Williamson County Sheriff's Office Training Center

PROPOSAL REQUEST

PROPOSAL REQUEST NO: 24

Description: Owner changes to project scope

A702

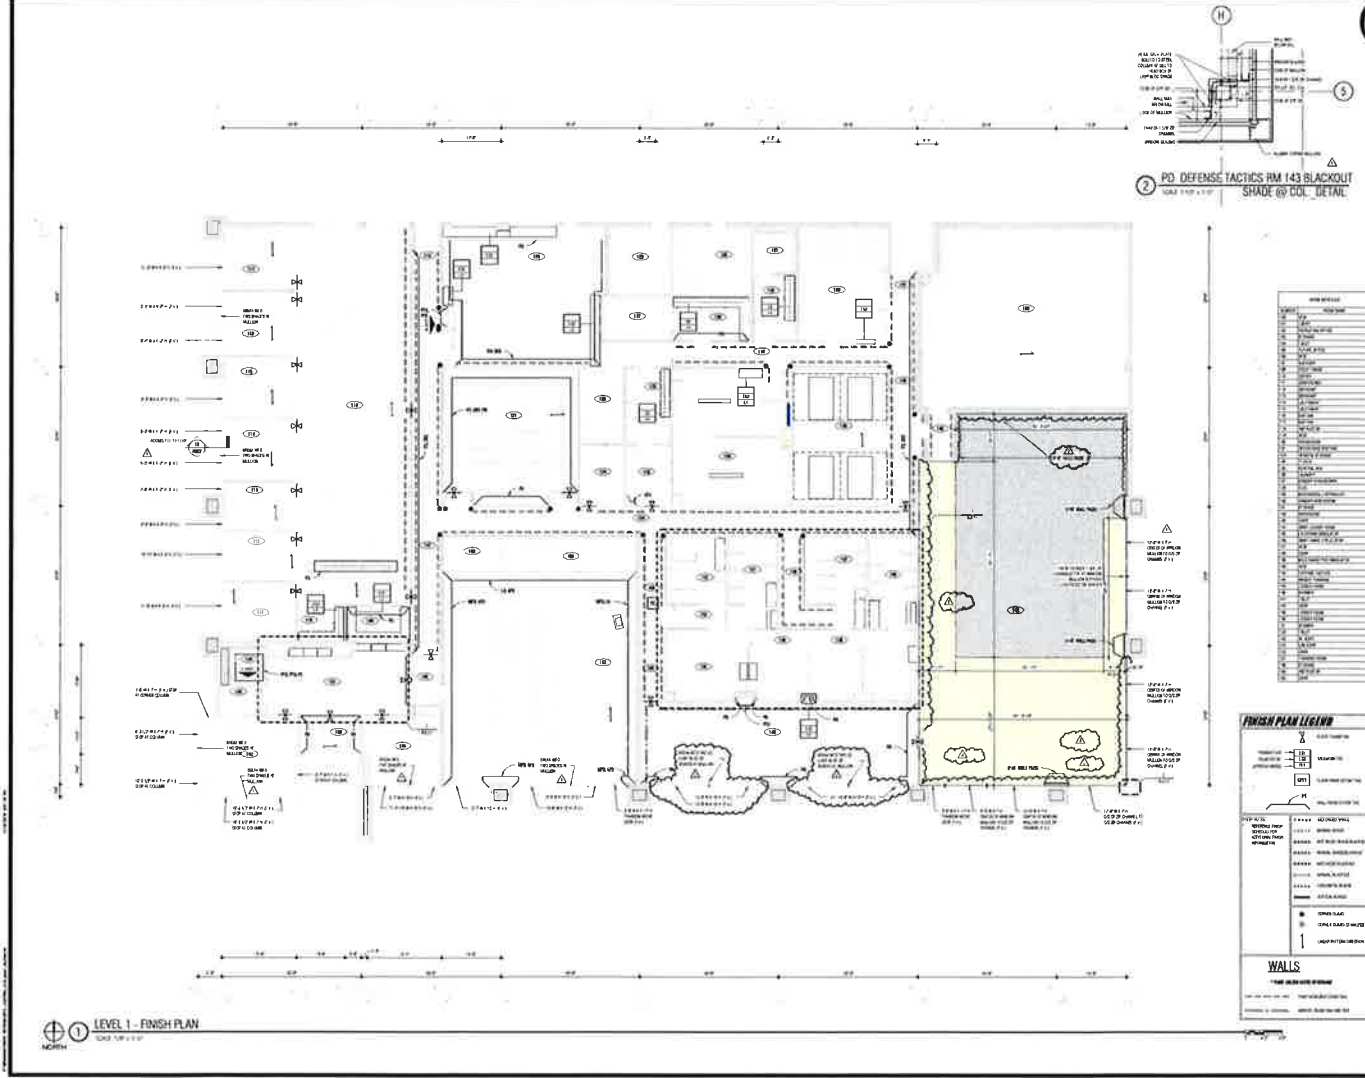
- Item No. 7. REVISE (2) DOOR WIDTHS
A. A702 – DOOR SCHEDULE DOOR TYPES; Room 137 Vest.; Revise width of doors 137A and 138A to 3'-6"
B. Provide any cost associated with security at control access Door 137A.

A903

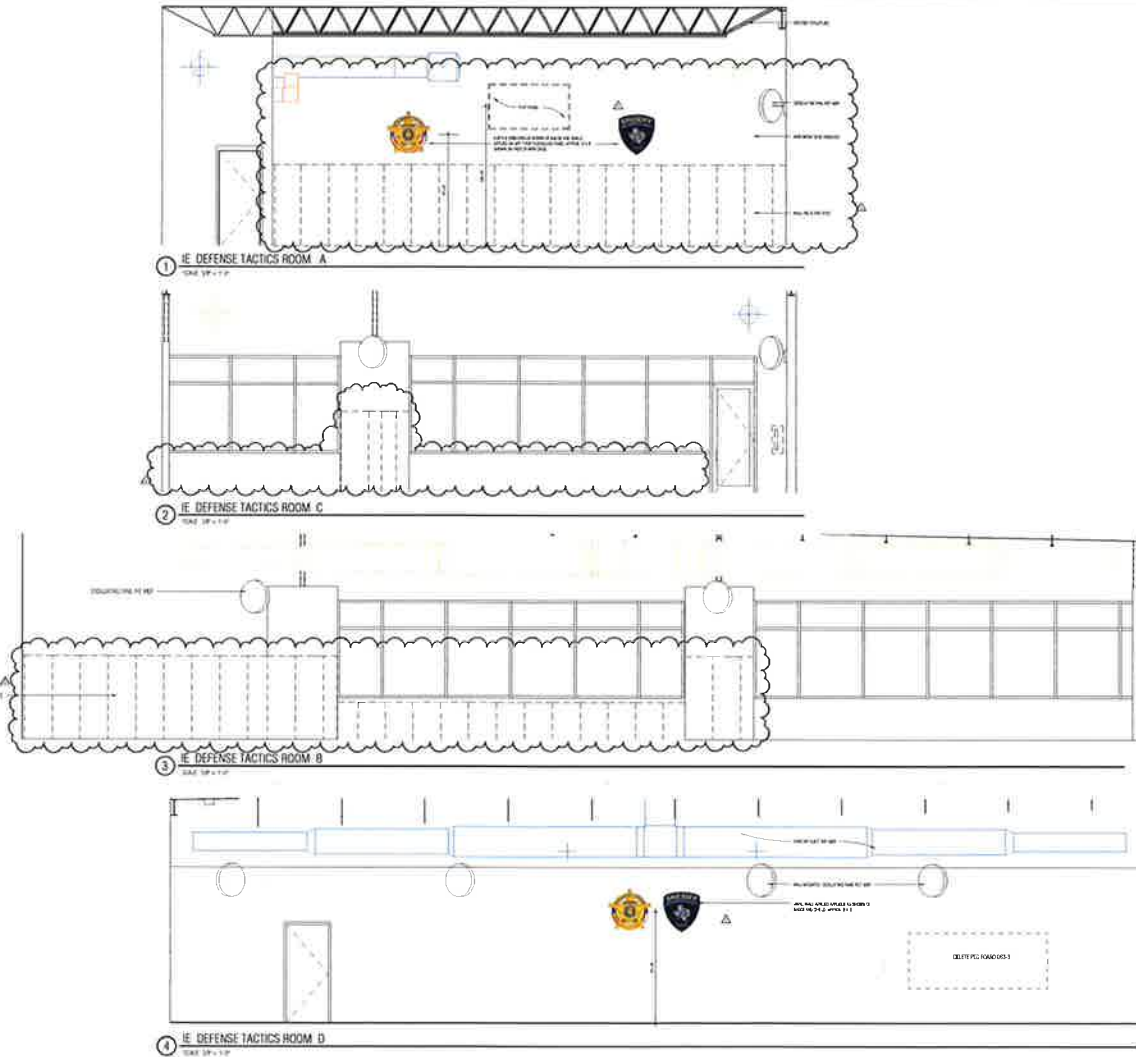
- Item No. 12. ADD ELECTRICAL STRIP
 A. A903 – INTERIOR ELEVATIONS; Room 144 Weight Training; Add vertical electrical strip at cabinets.
 B. E311 – FLOOR PLAN – POWER; Rm 144; Relocate outlet above base cabinet as vertical electrical power strip for phone charging station; center in wall.

E311

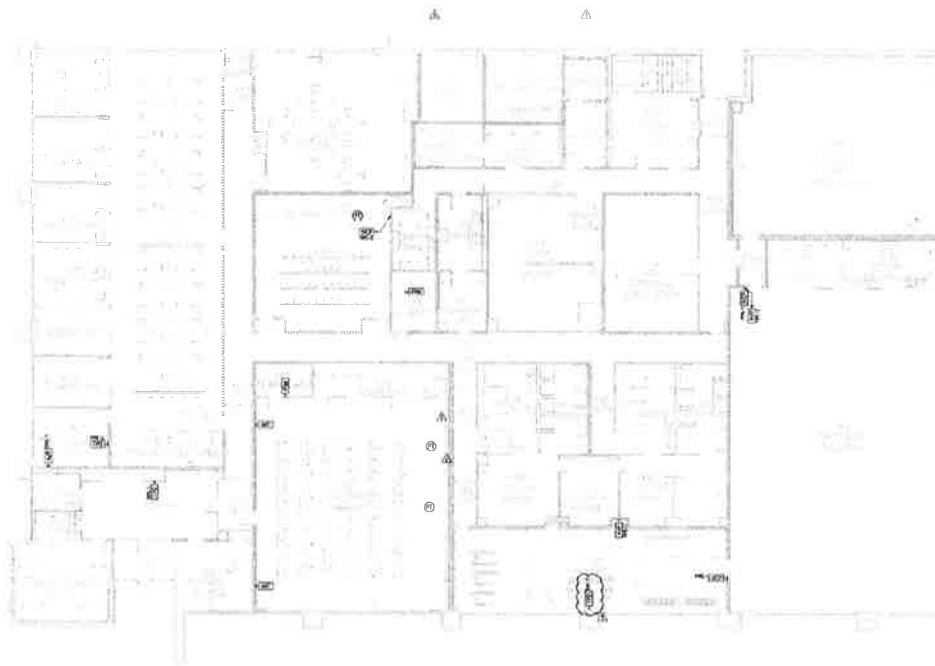
- Item No. 5. ADD & DELETE ELECTRICAL
A. E311 – FLOOR PLAN – POWER; Room 144 Weight Training; (4) four ceiling mounted TV receptacles to remain as installed, Add (1) wall mounted TV receptacle centered on column. Ref. Keyed Note 33.

B. Add (1) wall mounted TV receptacle, Rm 143 Defense Tactics; Ref. Keyed Note 33.
- Item No. 6. ADD ANCHOR RINGS
A. A212 – FLOOR PLAN – EQUIPMENT, INTERIOR ELEVATIONS, & SECTIONS; Rm 143 D.T.; Locate (3) three recessed anchor rings as shown. Ref. Detail 2/A212.

B. A800 - FINISH SCHEDULE & EQUIPMENT SCHEDULE, NOTES & LEGEND; Ref. Finish Schedule.
 C. E311 – FLOOR PLAN – POWER; Room 144 Weight Training; Add power for motorized shades and switch in Rm. 144

AV101

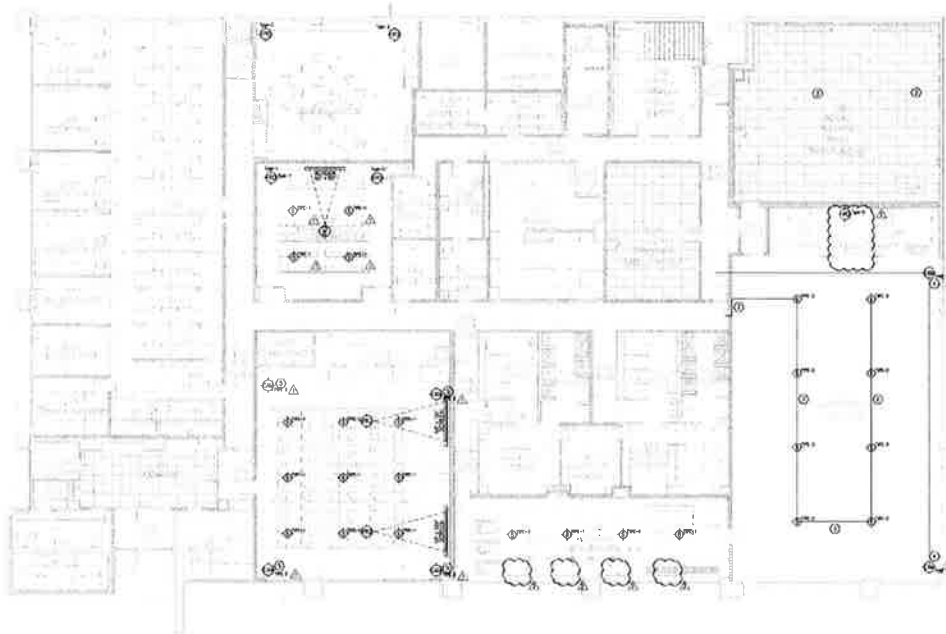
C. AV101 – FLOOR PLAN – AUDIO VISUAL; Room 144; Add (1) wall mounted FPD (to pilaster location)
D. AV201 – RCP – AUDIO VISUAL; Room 144; AV Infrastructure to remain; (4) four ceiling mounted.

AV201

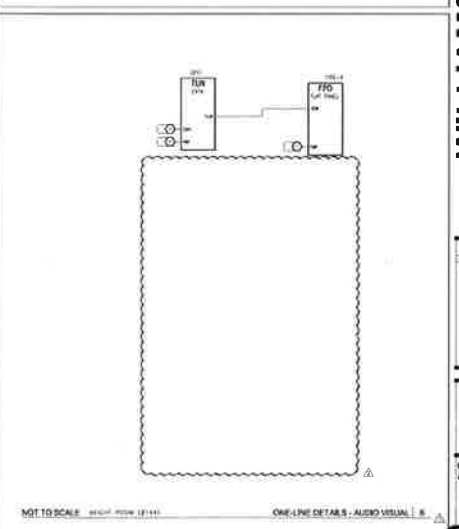
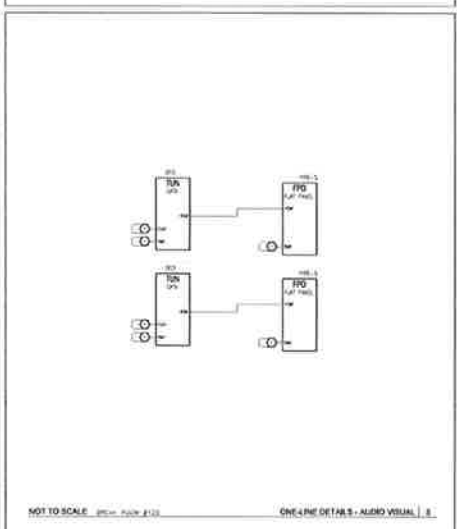
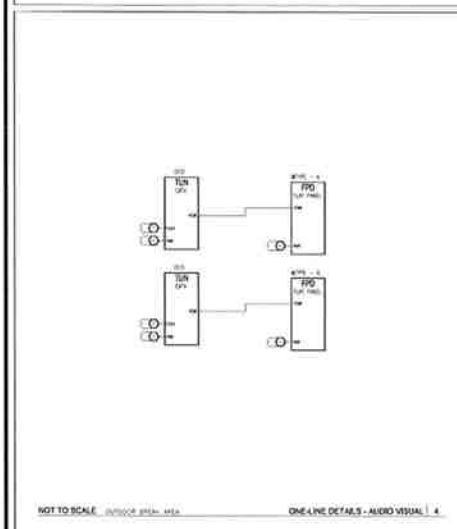
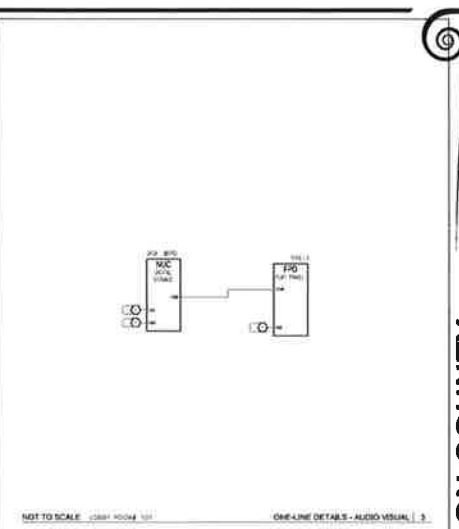
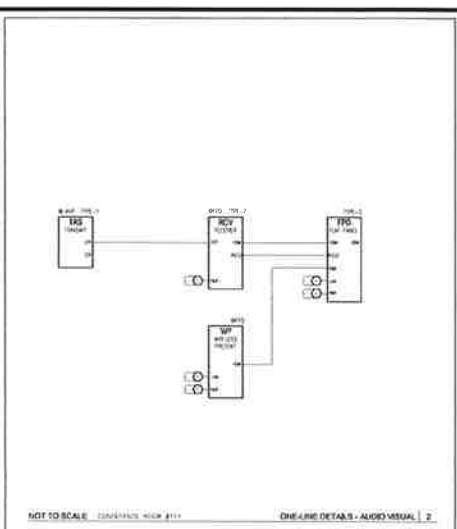
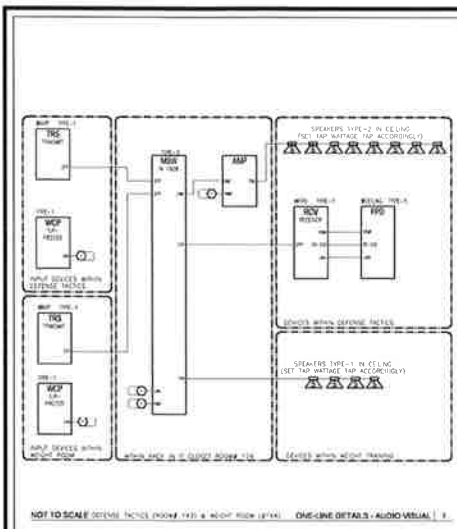
E. AV201 – RCP – AUDIO VISUAL; Room 143; Relocate ceiling mounted FPD from location in front of wire cage to center of North wall.
F. AV403 – GENERAL DETAILS – AUDIO VISUAL; Room 144 Weight Training; Clarify (1) one FPD and associated CATV tuner box. 1-Line drawing.
